(affected part number 45009K3Pro.S)

This Field Safety Notice (FSN) contains important customer information for patient safety and for the safe use of *exoplan*, our software for implant planning and surgical guide design.

**Internal exocad Reference:** #322799

**exocad product, commercial name:** *exoplan*

Figure 1: Sketch comparing the distance situation between sleeve, implant and drill for the wrongly entered drill (left) and the correct drill (right).

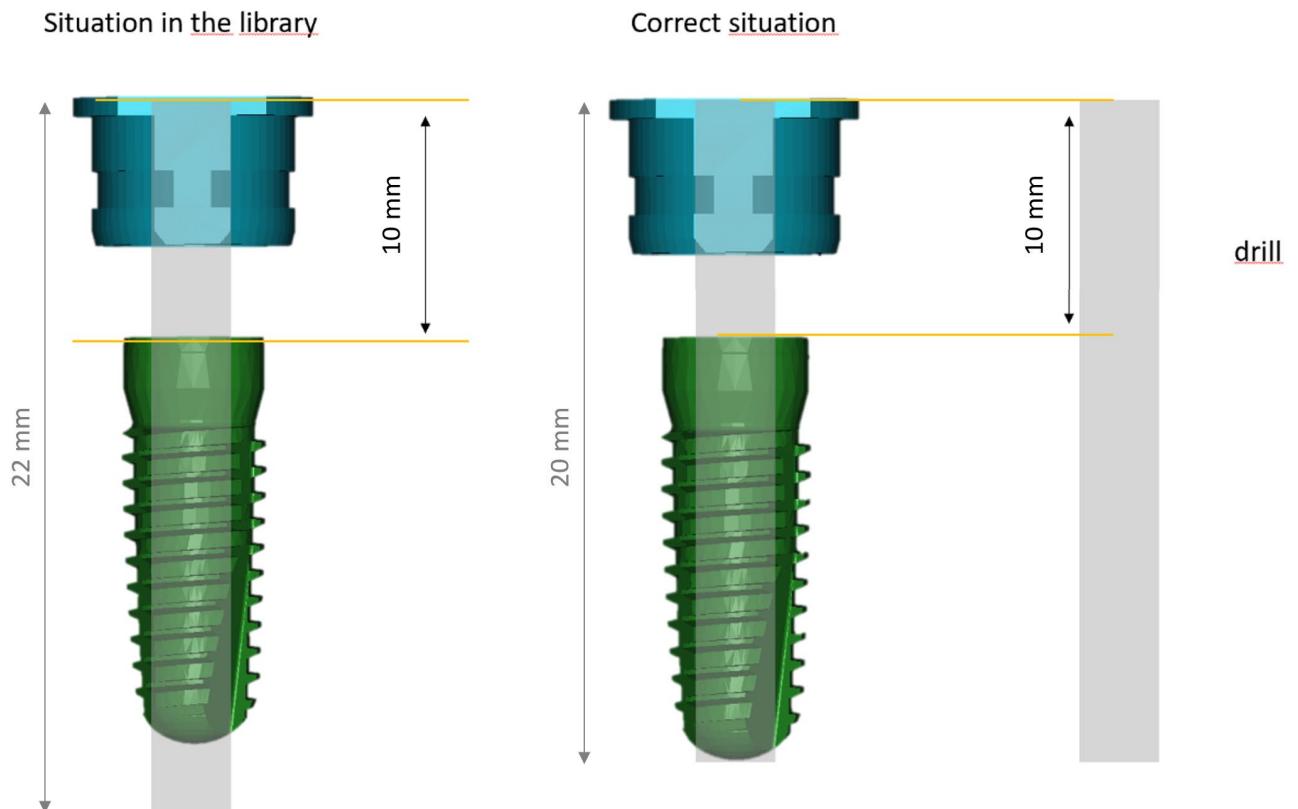
The issue is an incorrect specification in the Argon\_Rapid\_Surgery\_sleeve libraries, suggesting the use of a surgical drill that results in a 2 mm deeper drill hole than expected due to a dimensional error in the affected libraries.

During an update of data used in a library shipped with *exoplan* or made available on the download portal of exocad, it was found that the use of a specific combination of an implant, sleeve and surgical drill can result in a hole being drilled 2 mm deeper than expected.

The identified issue in the Argon Sleeve Library, where incorrect drill length information is reported, poses significant risks to patient health during dental implant surgeries. Specifically, the software indicates a drill length that is 2 mm longer than necessary. The software provides a default safety margin of 1.5 mm, which as a result of the incorrect drill length information, is insufficient, as it is also shifted by 2 mm. This error can lead to over drilling beyond the intended surgical boundary.

- 4) New library version of Argon\_Rapid\_Surgery\_sleeve have been released ( <SignatureDate>2024-05-07T14:47:36.6611068Z</SignatureDate>). Users can now download and install the new libraries.

- 1) Do not use the affected libraries - see section “Affected libraries” above.
- 2) Download the new libraries at <https://exocad.com/integration/exoplan-library-integration> or use exocad *Library Manager* from within *exoplan*.

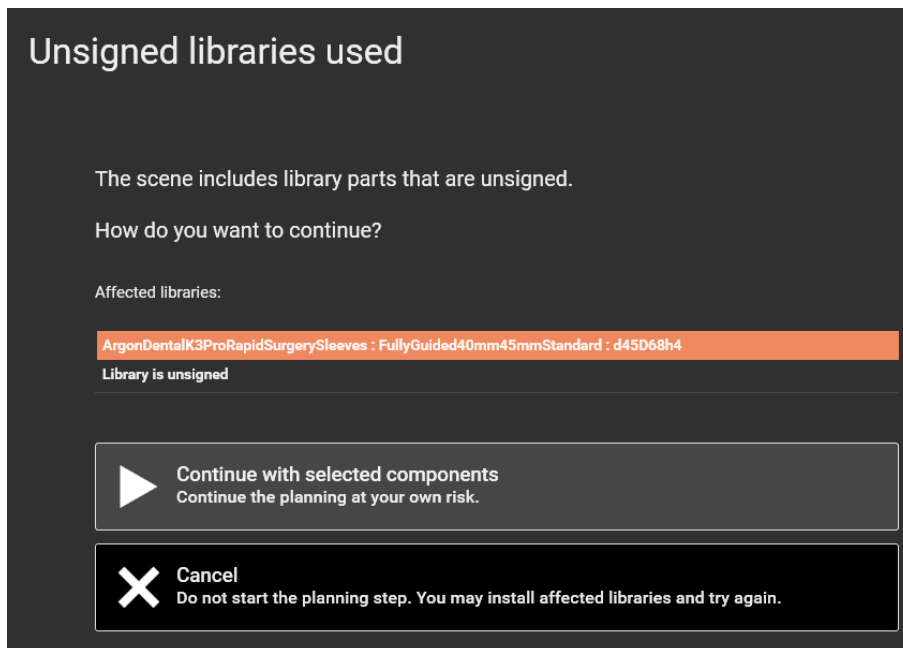
- 2) As a result of the blacklisting, if the user tries to select a component in the affected library, the user receives a message indicating that the selected sleeve library is marked as “unsigned” and should no longer be used. This message appears when the user selects the blacklisted library, as well as before the implant planning and surgical guide output data is generated. Users notified by this warning should click “cancel” and not “continue”. If users click continue, they continue at their own risk.

Figure 3: Unsigned library message of a blacklisted Argon® library to the user when loading a scene file that already contains the affected library.

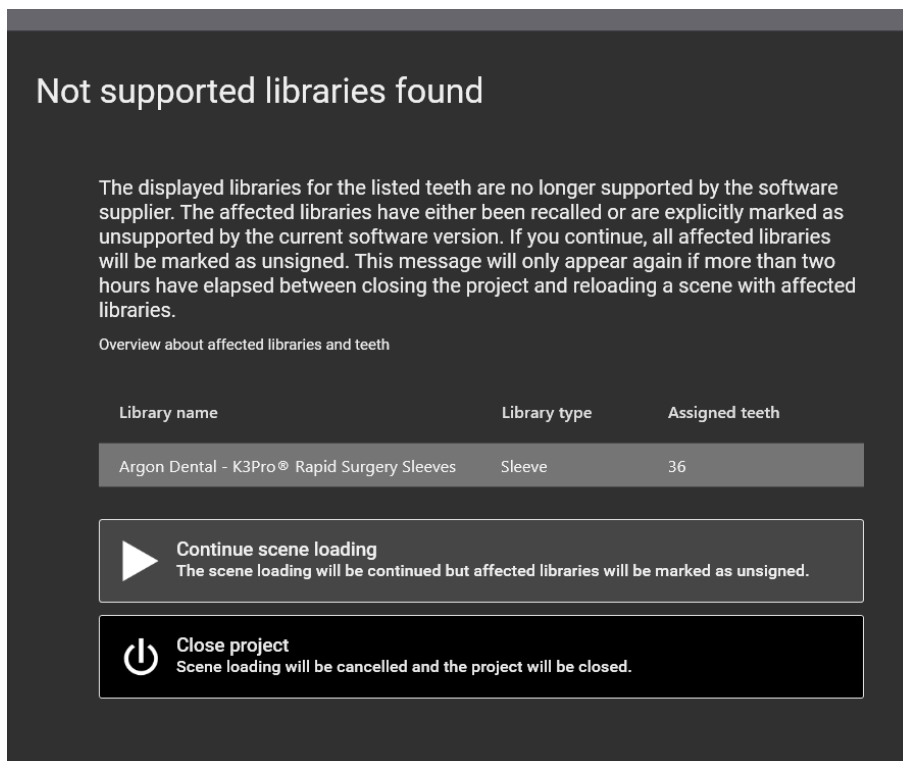
- 3) If an implant planning “scene file” (file containing all the information about a planning or design scene, e.g., workflow state, scene objects) is loaded into *exoplan* that previously used the blacklisted sleeve library in the implant placement planning, a warning message appears to inform the user about the unsigned library (see figure 3).
